UNITED STATES ENVIRONMENTAL PROTECTION AGENCY
Research Triangle Park, North Carolina 27711

January 14, 1994

Subject: Review of CPP Report on Wind Tunnel Modeling of Cape Industries Facility of
Wilmington, NC

Equivalent Building Height Tests

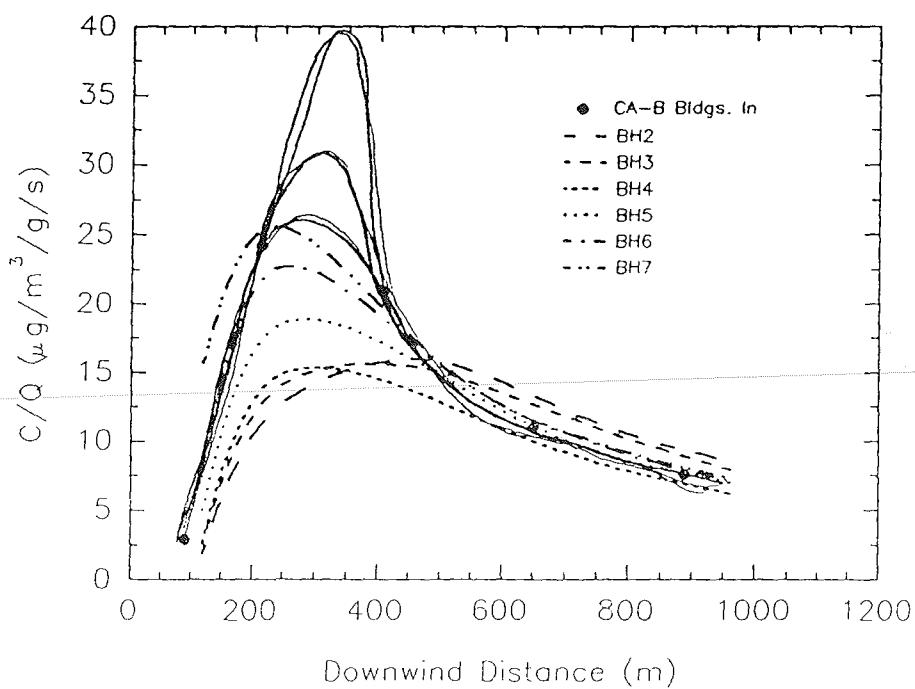
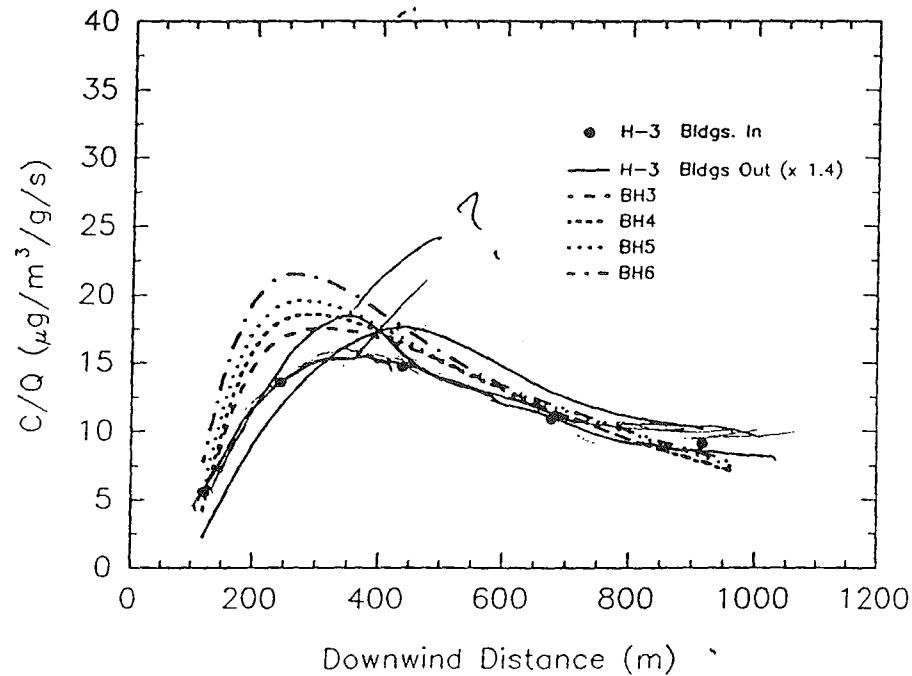
6. Agreed, B-3 is mislabelled on page iii.
7. Agreed, I complained about the lack of detail earlier.
8. I believe the location of the single solid structure is immediately upwind of the stack in question, with broad side perpendicular to the wind -- these solid buildings are not shown in the photographs. In fact, these solid buildings were never placed within the plant complex. They were, instead, placed within an area with enhanced roughness, presumably matching the roughness of the plant complex (see Figure 5, page 37).
